GARRANE GREEN ENERGY LIMITED

GARRANE GREEN ENERGY PROJECT AT BALLYNAGOUL, CREGGANE AND GARRANE, CO. LIMERICK

SUBMISSION ON THE OBSERVATIONS ON PLANNING APPLICATION REF: ACP-323635-25

JANUARY 2026

Figure 1. Estimated extent of neutral grassland/wet grassland mosaic (GS1/GS4) which supports elements of marsh habitat (GM1).

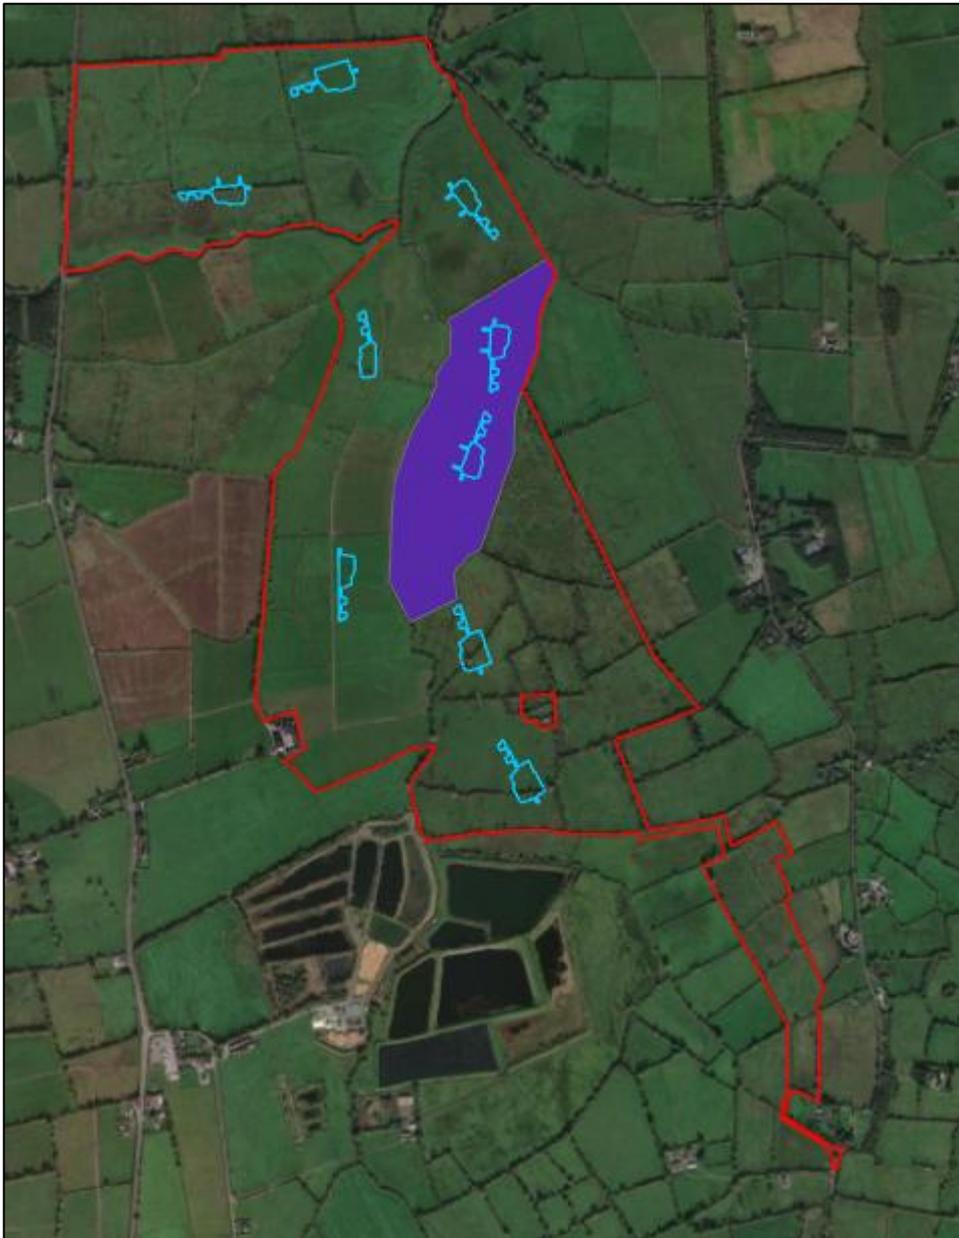
The Heritage Council (HC) submission has reviewed in some detail Chapters 6, 7 and 8 of the EIAR as well as the NIS. While they write (in para. no. 1) "*In a general sense, we believe that the main ecological designations (including those identified in the Natura Impact Statement) have been fully considered, and in broad terms we have no objections to the conclusions*", a number of points are raised which require clarification. The main points raised, which refer largely to the area to the east of the Charleville Stream and Maigue River that has been classified as wet/neutral grassland (GS4/GS1), are addressed in the following:

By way of clarification, a drawing showing the fields where marsh was recorded as part of the wet grassland / neutral grassland mosaic is presented in the accompanying Figure 1. (this drawing is derived from the baseline information used to compile **Section 6.3.3.2** of the **EIAR** and represents the best estimate by the field surveyor of the distribution of marsh within the wet grassland complex as mapped in **EIAR Figure 6.3**). This area amounts to an estimated 17.86 ha (out of a total of 65.14 ha of wet grassland/neutral grassland mosaic within the site). It is noted that as the marsh element occurs in patches rather than extensive areas it was not feasible to map the marsh areas separately from wet grassland. Also, wet grassland and marsh are botanically fairly similar – in 'Wet grassland' (GS4) Fossitt (2000) writes "*Wet grassland frequently grades into marsh – GM1 and there are many similarities in the range of species present in both habitats*".

Paragraph 5 of Biodiversity (pg. 3) refers to an area of 8.05 ha of neutral and wet grassland to be lost. It is noted that the figure of 8.05 ha (as given in Table 8.21 of EIAR) was a typographical error and the correct figure is 6.04 ha (as given in **Chapter 6** of **EIAR**). Of the 6.04 ha, the amount which will be lost within the fields where elements of marsh occur is estimated at 1.26 ha. As an estimated total of

Figure 3. Extract from paper with approx. location of Bruree circled in red.

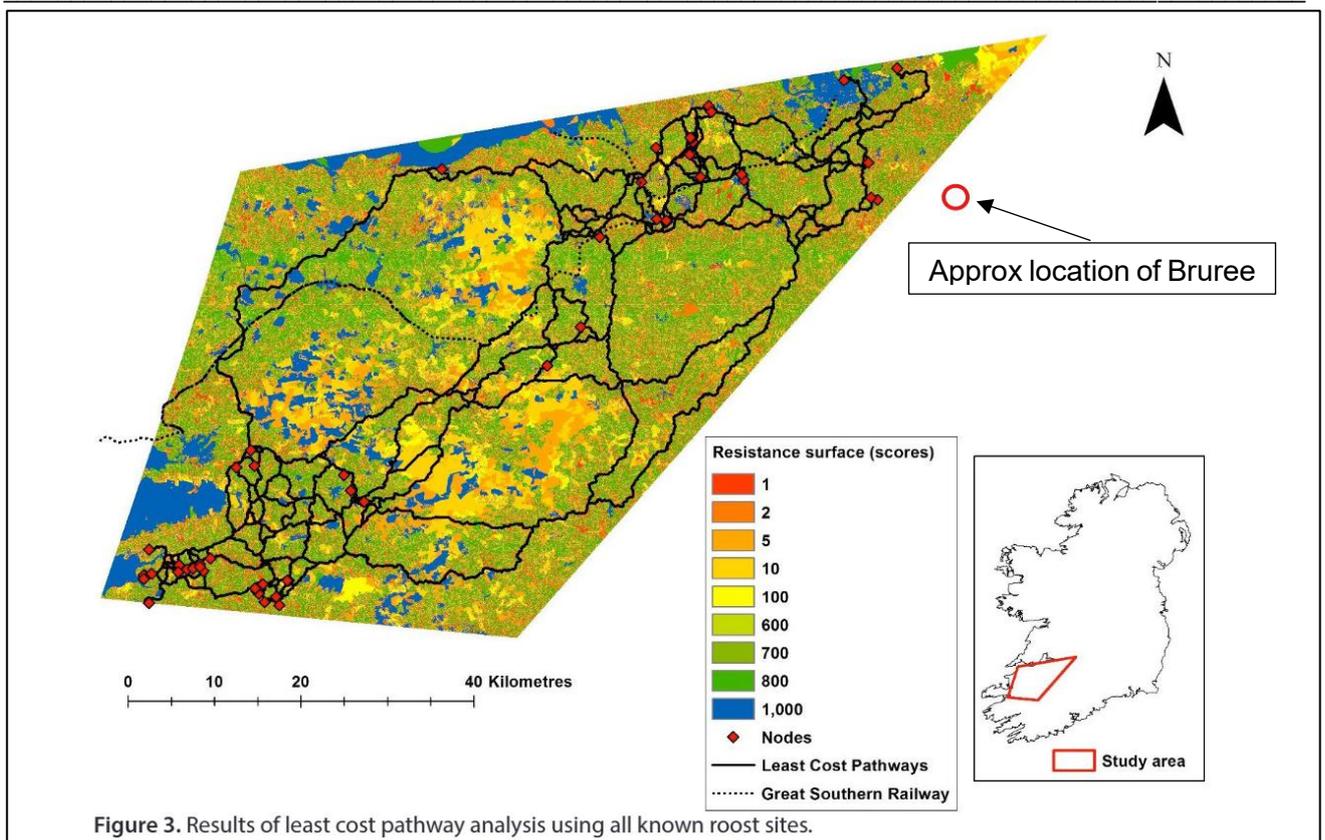
“What is more, a recent study of lesser horseshoe connectivity has identified the Bruree area in south Limerick as a key potential corridor of connectivity between roosts in Limerick and Kerry.³ The lesser horseshoe recording in the bat survey for Garrane, which is in Bruree, could therefore be much more significant than the EIAR suggests. More static detection survey, especially in October, needs to be undertaken before any planning decision is made on this project.”

The study cited here: Lenihan, P., Flaherty, M., Finch, D. and McAney, K. 2021, modelling connectivity pathways between Lesser Horseshoe Bat (*Rhinolophus hipposideros* (Bechstein) maternity roosts in Ireland, provides an excellent analysis of potential pathways and routes of connectivity between known Lesser Horseshoe bat maternity roosts within Counties Limerick and Kerry. The study however, has no mention of Bruree and the village is not included on the map of potential least cost routes for these bats (Figure 3 of paper - extract below), actually lying approximately 3.5km outside of the study area of the paper to the south-east.

Figure 1 – Excerpt from Figure 12.10 of the EIAR – Route Screening Analysis Map

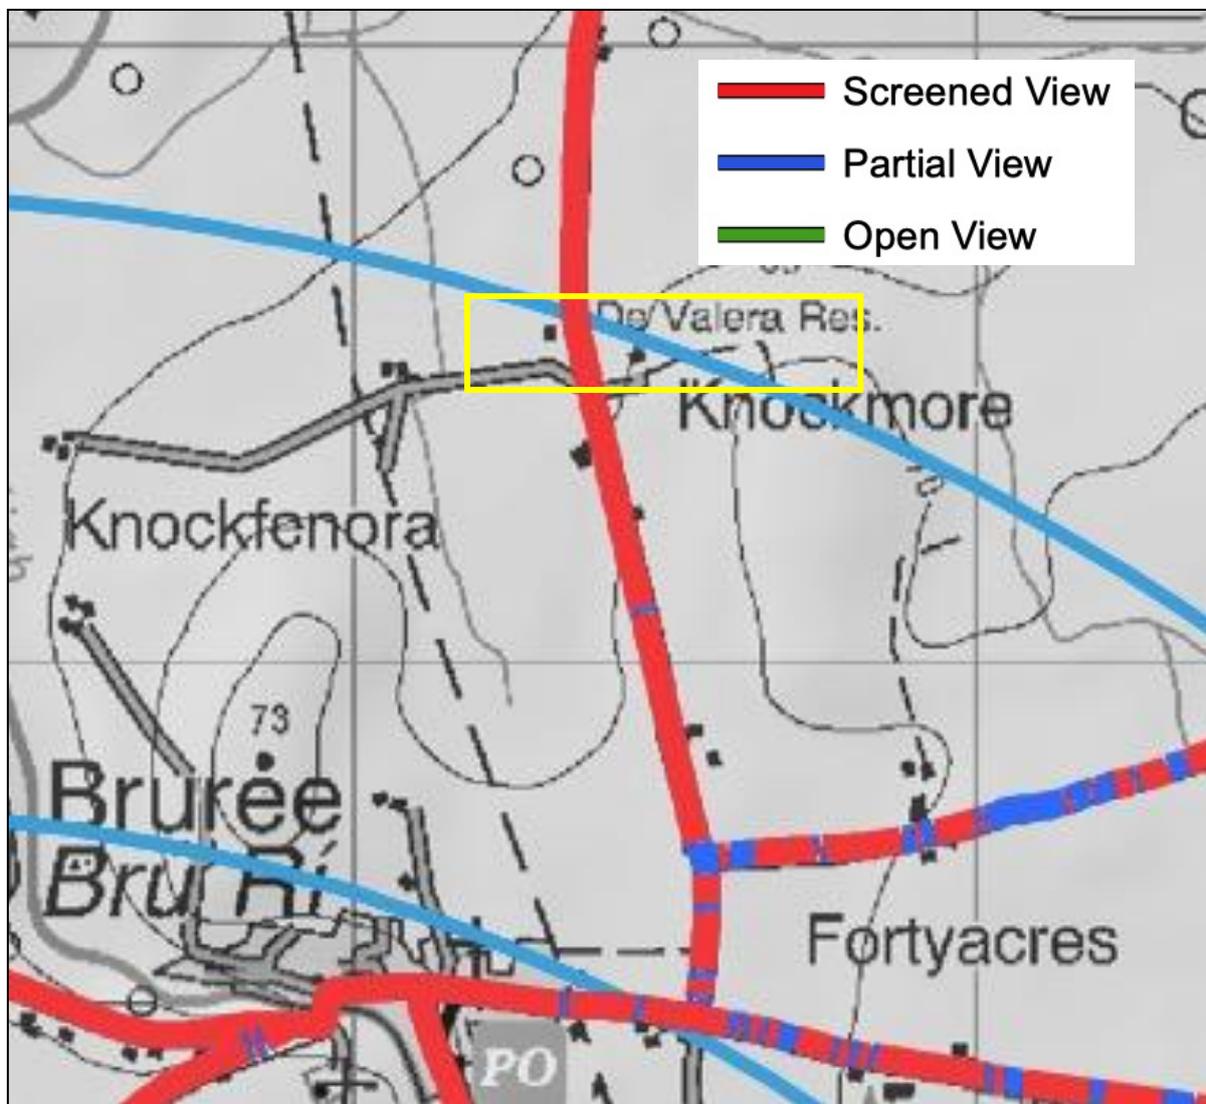
The OPW submission states that “Despite the proximity of De Valera’s cottage, the visual impact on this heritage property has not been undertaken. The OPW requests that An Coimisún Pleanála seek verifiable visual impact assessment documentation as additional information (e.g. wireframe/photomontage) to demonstrate the visual impact, if any, on this statutorily protected heritage property. Any impact assessment should include cumulative impacts”.

Although the OPW request is not an unreasonable one, it is considered unnecessary. From a visual receptor (visitor) perspective, the experience of visiting De Valera’s Cottage would appear to be largely an internal / insular one i.e. inside the cottage rather than relating to the particular landscape and visual setting of the cottage. Furthermore, the cottage is surrounded by dense vegetation at close quarters and the Route Screening Analysis (RSA) undertaken as part of the LVIA illustrates that there is no visibility of the proposed turbines anywhere in the vicinity of the cottage (See Figure 1 below).
